Re: Niagara Mohawk Power Corporation  
Nine Mile Point Nuclear Station Unit 1  
Docket No. 50-220

APPLICATION FOR AMENDMENT

## Proposed Change To The Technical Specifications

## PROPOSED CHANGES TO THE TECHNICAL SPECIFICATIONS

FIGURE 6.2-2  
 NMP-JAF NUCLEAR SITE  
 OPERATION ORGANIZATION

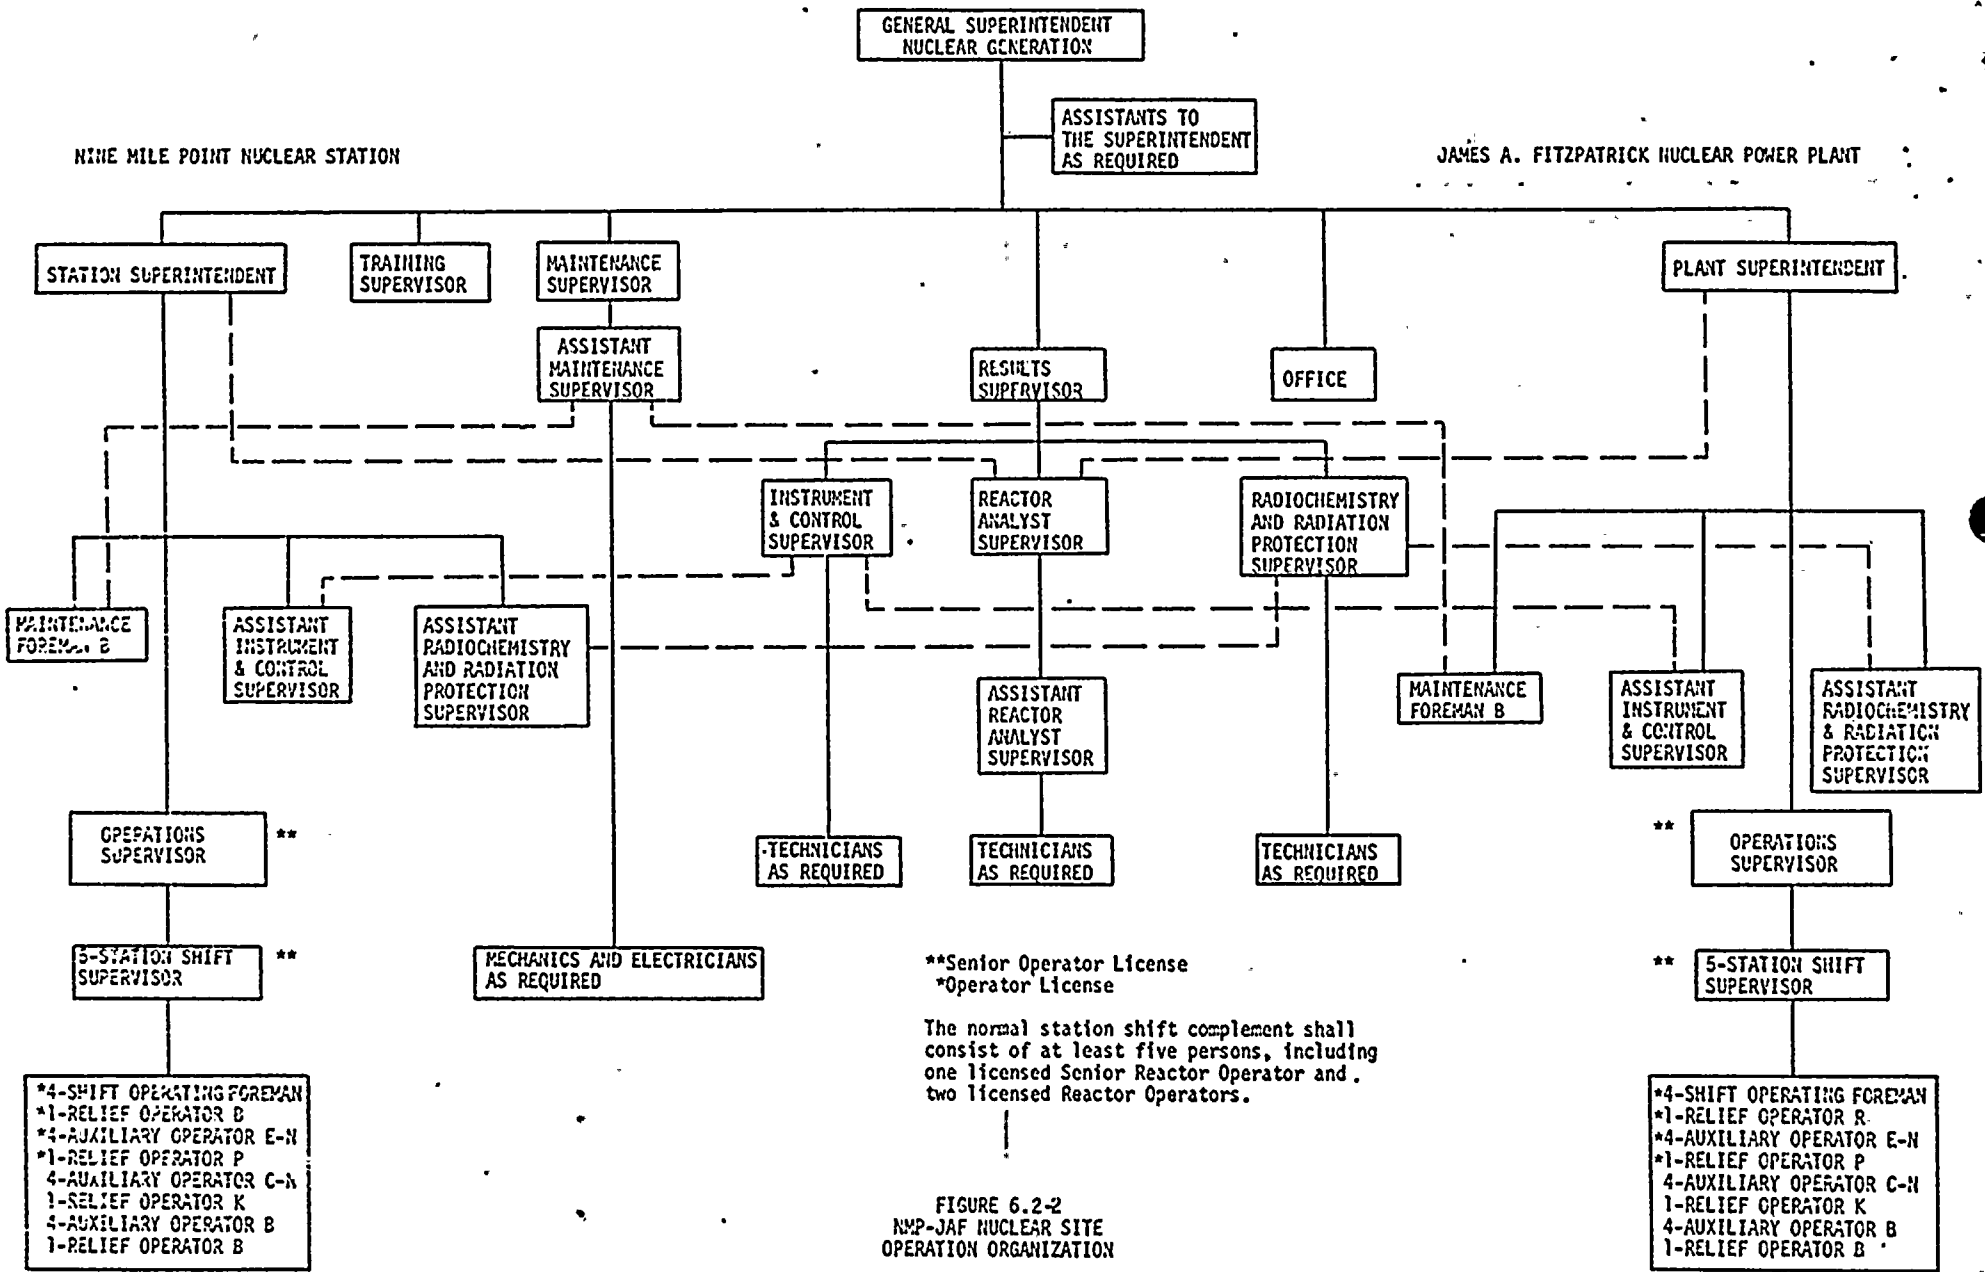
The first change will provide continuity in functional titles for both nuclear and non-nuclear positions at Niagara Mohawk's generation facilities. The "Operations Supervisor" will assume all the responsibilities of the position previously titled, "Assistant to the Superintendent for Operation," including reporting directly to the "Station Superintendent" (Nine Mile Point Unit 1) or "Plant Superintendent" (James A. FitzPatrick) respectively. The second change involves the addition of an "Assistant Maintenance Supervisor" who reports directly to the "Maintenance Supervisor." The position was added to reflect the additional work load of operating both Nine Mile Point Unit #1 and the James A. FitzPatrick Plant.

<u>ITEM</u>	<u>LOCATION</u>	<u>CHANGE</u>
Figure 6.2-2	Section 6.0 "Administrative Controls," Page 247	Change Titles "Assistant to the Superintendent for Operation" to read as follows:  "Operations Supervisor"  Add: "Assistant Maintenance Supervisor"
